DEVIATION REQUEST (Attach diagrams, figures, and other documentation to clarify request)

A deviation from the standards of or in Section **Chapter 6 6.4.1 and Table 6-4** of the Drainage Criteria Manual (DCM) is requested.

Rural Minor Collector – Arroya Lane
Allowable culvert overtopping – major drainage system maximum depth of 12"

RETREAT AT TIMBERIDGE FILING NO. 3
CONSTRUCTION PLANS
STREET IMPROVEMENT PLANS
ARROYA LANE

Crossing - Arroya Lane, Design Discharge - 1468.0 cfs (SR MDDP 100 YR.)

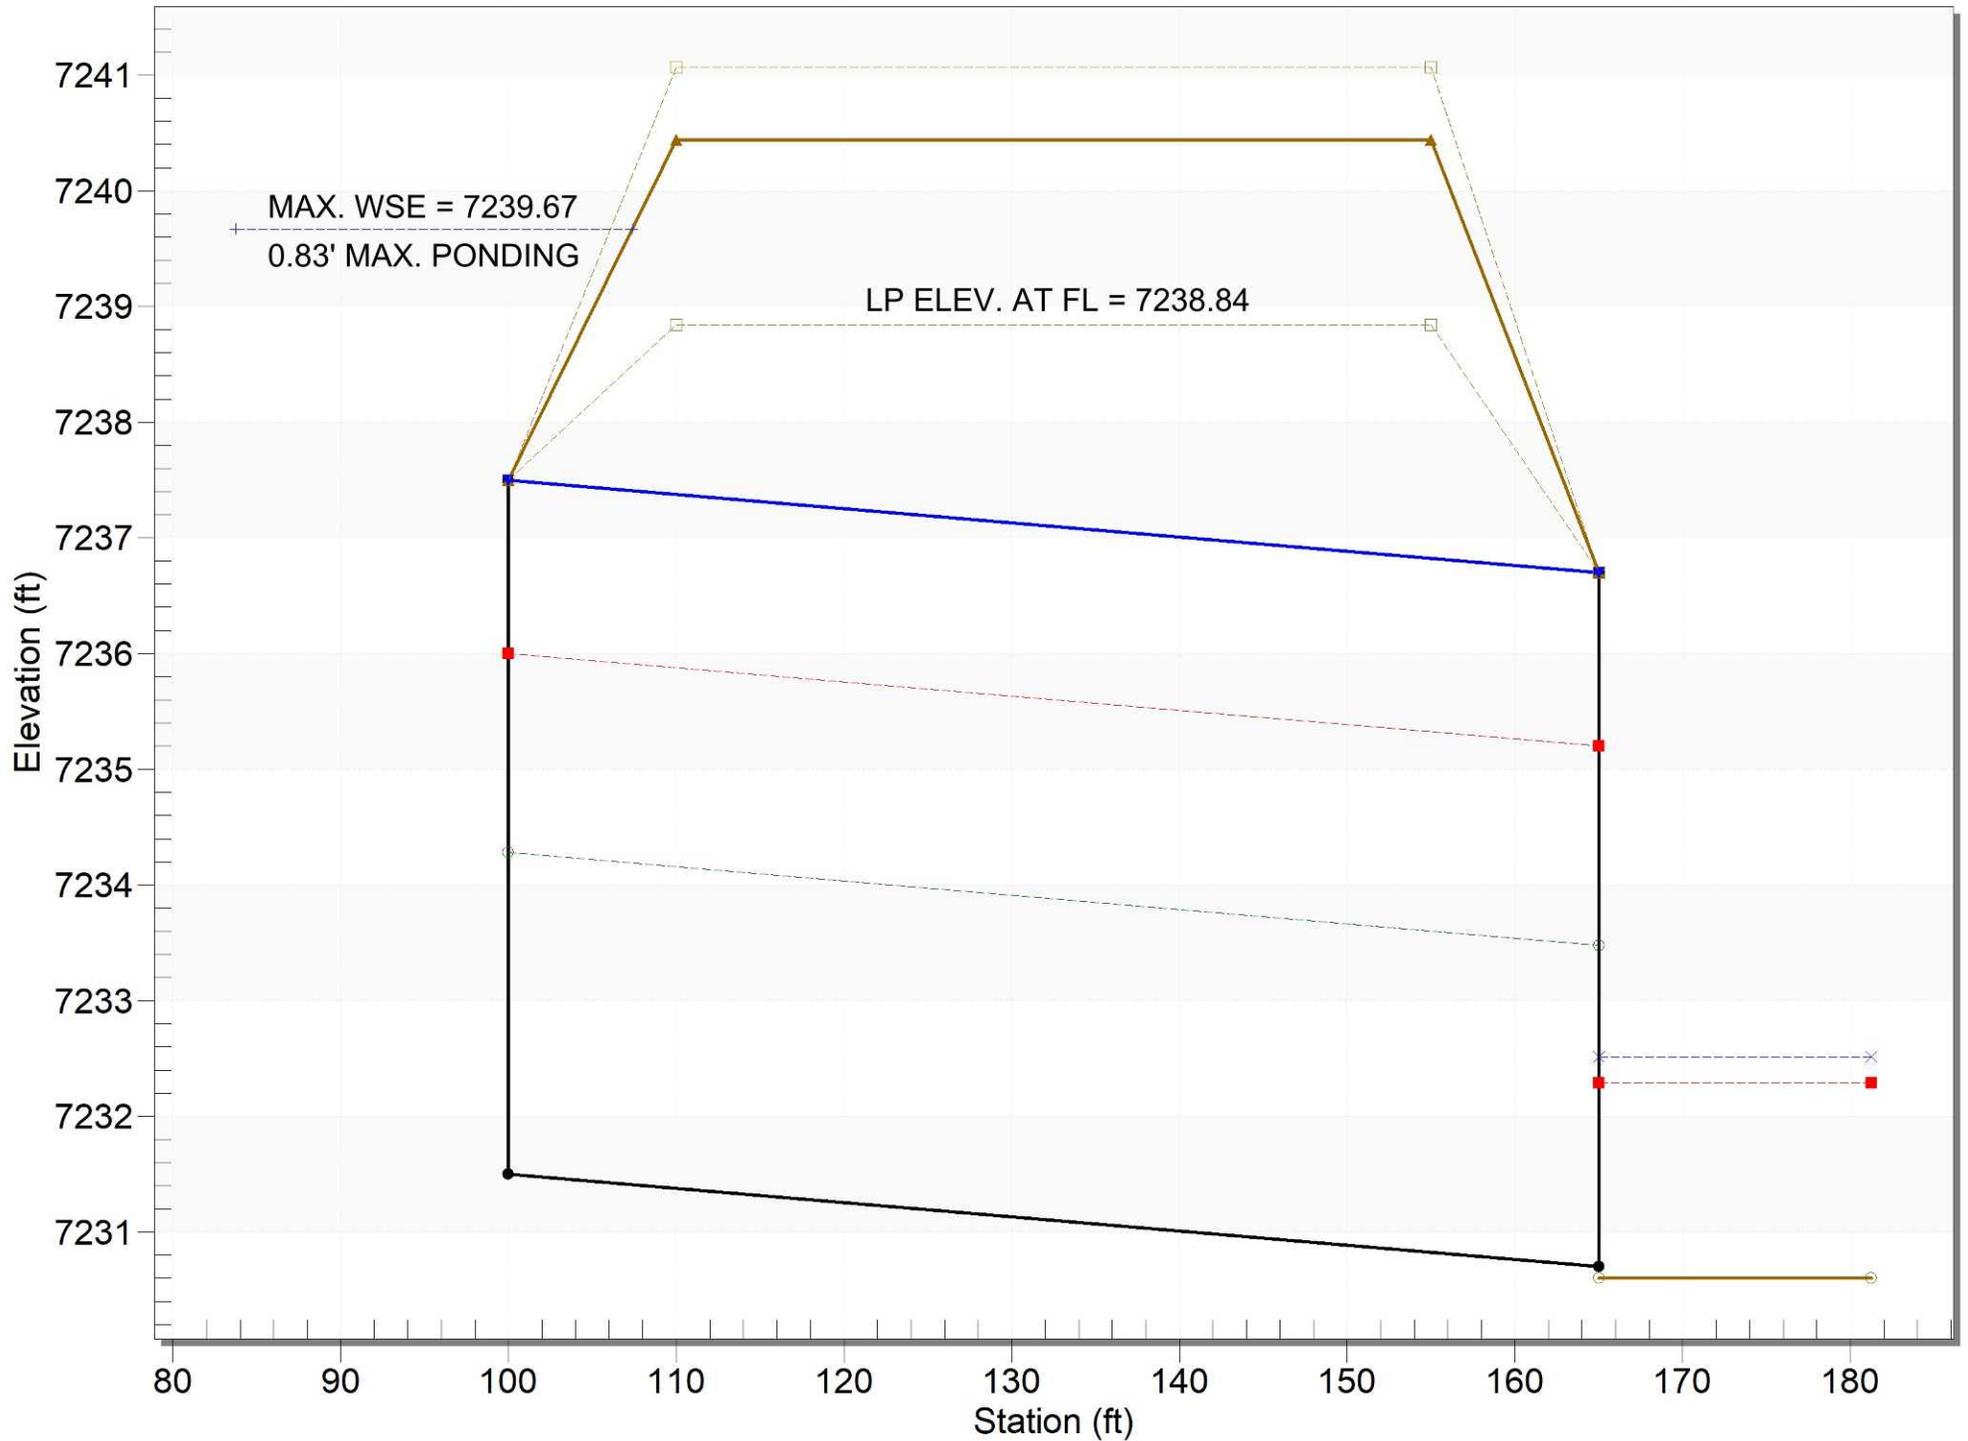
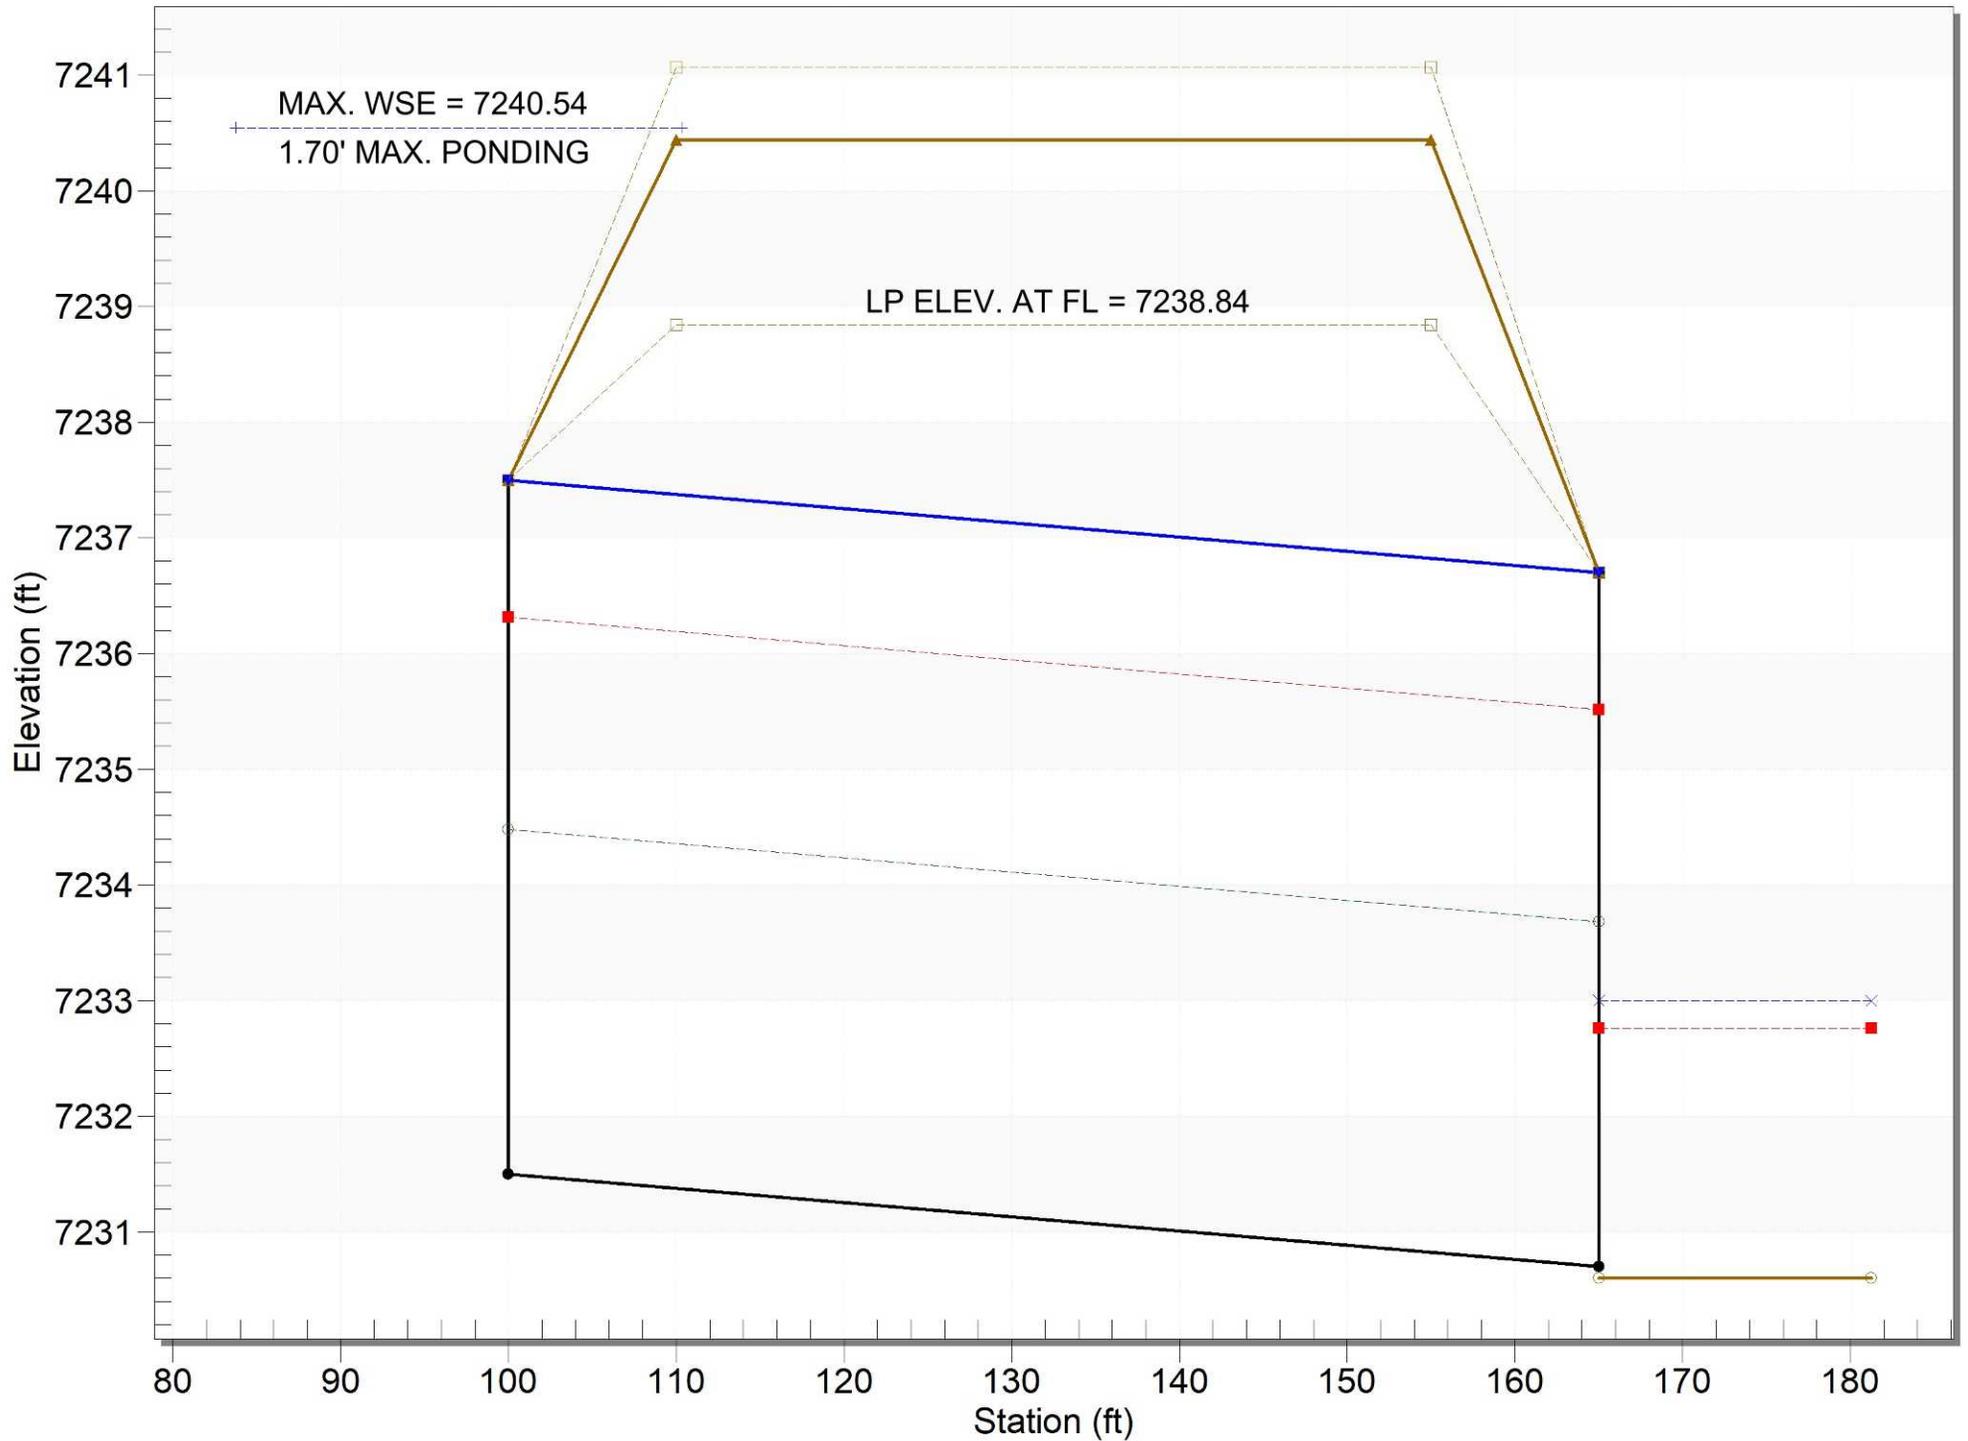
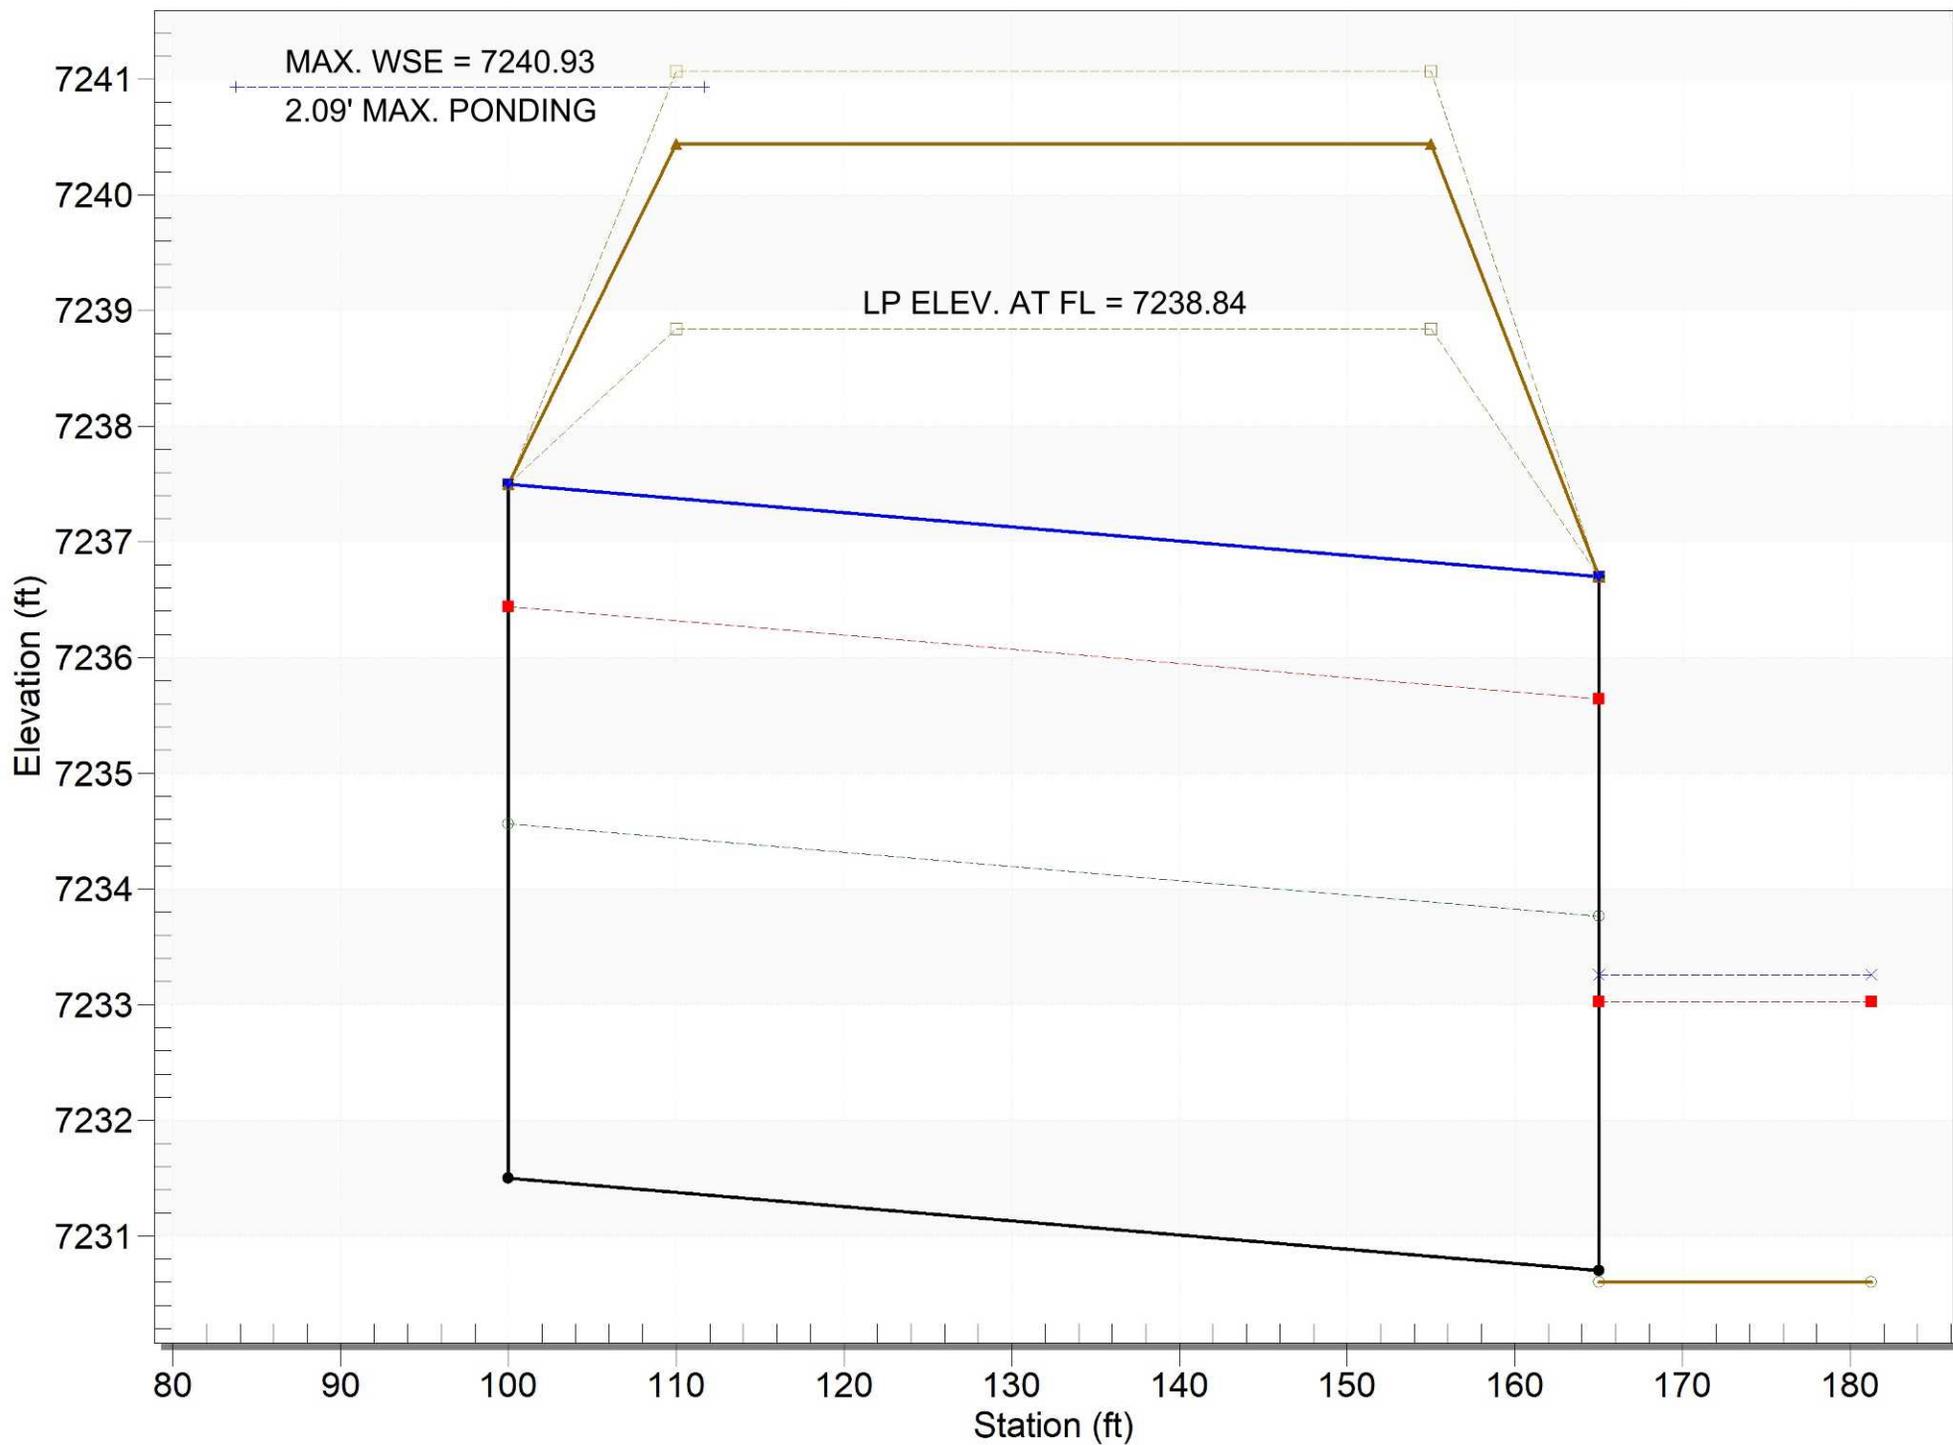
More specifically: SC DBPS 100-yr. flow of 2170 cfs will have a max. depth at the low-point in Arroya Lane. of 1.70'
FEMA 100-yr. flow of 2600 cfs will have a max. depth at the low-point in Arroya Lane of 2.09'
